DOCUMENTATION TRANSMITTAL

Documentation Description: Nonconformance Reports - C-00772 & 4924

NONCONFORMANCE REPORT

NONCONFORMANCE REPORT

DETAIL FOR BOLT PATTERN

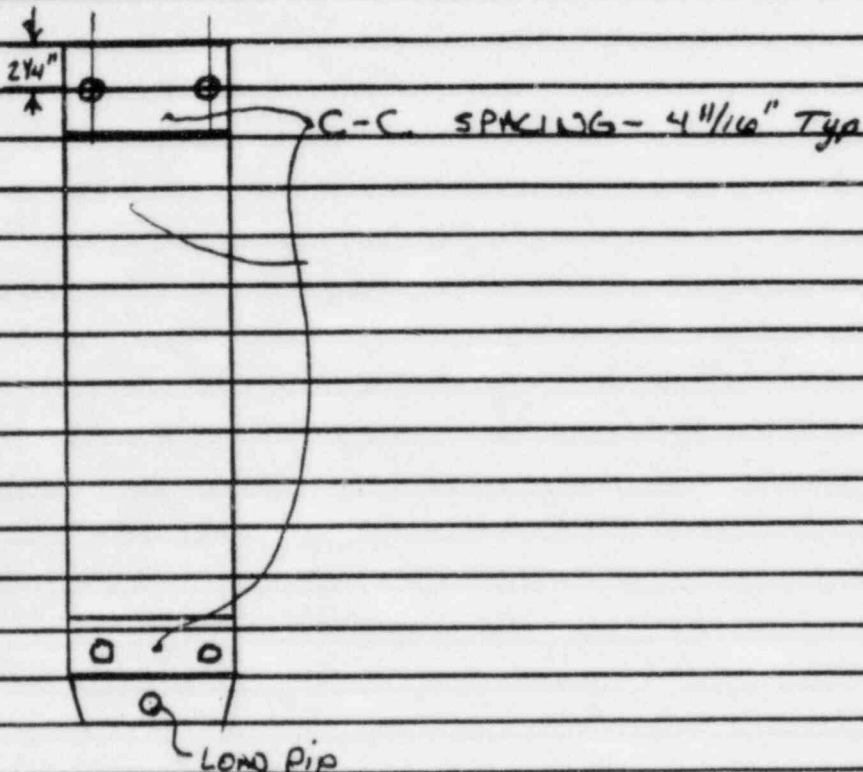
13 NONCONFORMANCE
CONTRARY TO THE ABOVE, THERE IS NO CRITERIA CONTAINED IN DWG, SPEC OR ITT GRINNELL LCDS TO VERIFY THE OVERALL ORIENTATION AND CONFIGURATION FOR SIZE 5 SWAY STRUT PIPE CLAMP. AT PRESENT THE ITT GRINNELL LCDS SHOWS THE E-TAKE OUT AND G STOCK SIZE BUT DOES NOT SHOW THE PRESENT BOLTING PATTERN FOR THE CLAMP. LEAVING
(SEE PAGE 3 OF 3 FOR DETAIL)

THE ACCEPTABILITY OF THE CLAMP INDETERMINATE.

PROJECT ENGINEERING DISPOSITION - IS USE AS IS PROVIDED
IT CAN BE SHOWN THAT THE PIPE CLAMP IS PART OF AN
ITT GRINNELL FIG. 211, SIZE 5 SWAY STRUT ASSEMBLY SHIPPED
TO THE SITE AS A UNIT. THE INSPECTION PROGRAM AT THE
SITE OF MANUFACTURE WOULD HAVE APPROVED THE ASSEMBLY,
INCLUDING PIPE CLAMP, PRIOR TO ITS SHIPMENT.

IF THE PIPE CLAMP IN QUESTION ON THIS NCR CANNOT
BE SHOWN TO BE ONE THAT WAS PART OF A FIG. 211, SIZE 5,
RIGID SWAY STRUT, THEN PROJECT ENGINEERING DISPOSITION
IS TO REJECT THE ITEM. ITT GRINNELL DOES NOT FURNISH
DETAILED DIMENSIONS OF THE PIPE CLAMPS FURNISHED AS
PART OF SWAY STRUT ASSEMBLIES.

REJECT - PER PROTECT ENG DISPOSITION DATED 12/8/83, SUBJECT
PIPE CLAMP CANNOT BE VERIFIED AS A PART OF
FIG. 211 SIZE 5 SWAY STRUT. THEREFORE SUBJECT CLAMP
SHALL NOT BE UTILIZED FOR PIPE SUPPORT O-618-1-30.
CLAMP SHALL BE SEgregated UNTIL ITT GRINWAL CAN
FURNISH THE DATA REQUIRED IN BLOCK 13 OF THE NCR
FOR QUALITY VERIFICATION.

CUSTOMER: CONSUMERS POWER CO.
 ORDER OR CONT. NO. FO. # 7220-M103AC
 JOB NAME: V. 21288 1 & 2 HGR. MATL.
 MARK NO. 50-CHOC-31-H2(G)
 SKETCH NO. 0-515-1-30 (G)
 SHEET 1 OF 1 REV. 1

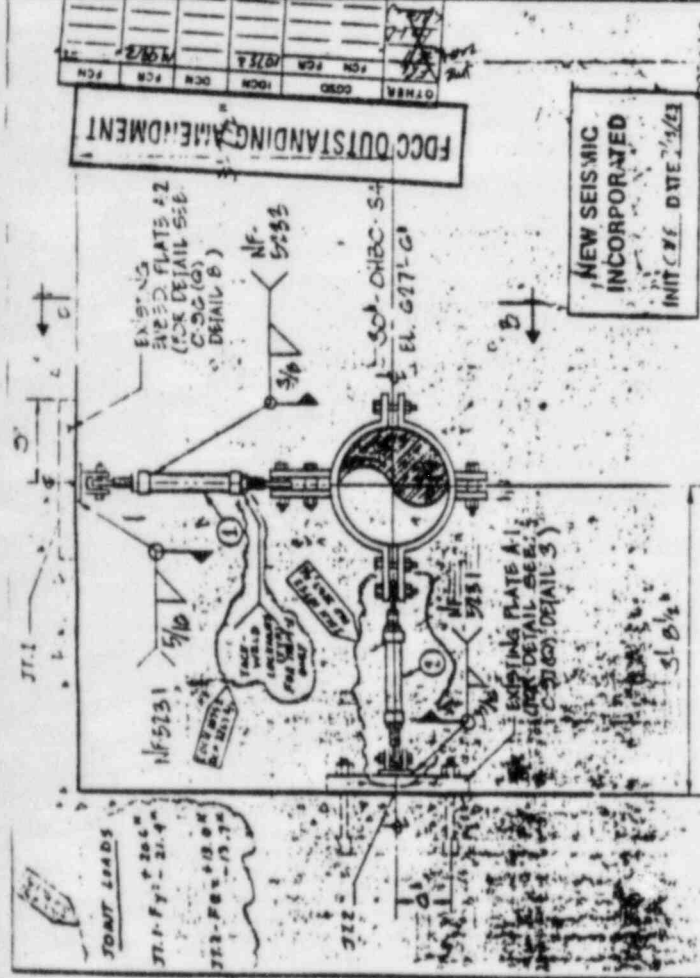
REASON FOR CHANGE
ITEM 1 - FIG 211 SIZE 4 COULD NOT BE DELIVERED IN TIME FOR CONSTRUCTION

EXISTING CONDITION
FIELD REDLINE WAS ISSUED CHANGING ITEM 1 TO A NPS # 14 SWAY STRUT. THIS REDLINE WAS REJECTED BY PROJECT BECAUSE IT WAS OUT OF SCOPE OF THE REDLINE PROCEDURE. PER CONVERSATION WITH R.E. J. ANCSIN, THIS NPS STRUT IS NOT CAPABLE OF CARRYING THE REQUIRED LOAD.

REASON: TO RESOLVE FCR NO. CG 50-159 AND TO INCORPORATE NEW SEISMIC LOADS

DESCRIPTION OF CHANGE
CHANGE ITEM 1 TO A FIG 211 SIZE 5 SWAY STRUT WITH 30" PIPE CLAMP WITH W = 2'-1"

DESCRIPTION: 1. CHANGED THE "Z" RIGID STRUT TO ONE OF LARGER CAPACITY. 2. LOCKNUTS FASTENED ON THE "Y" RIGID STRUT.
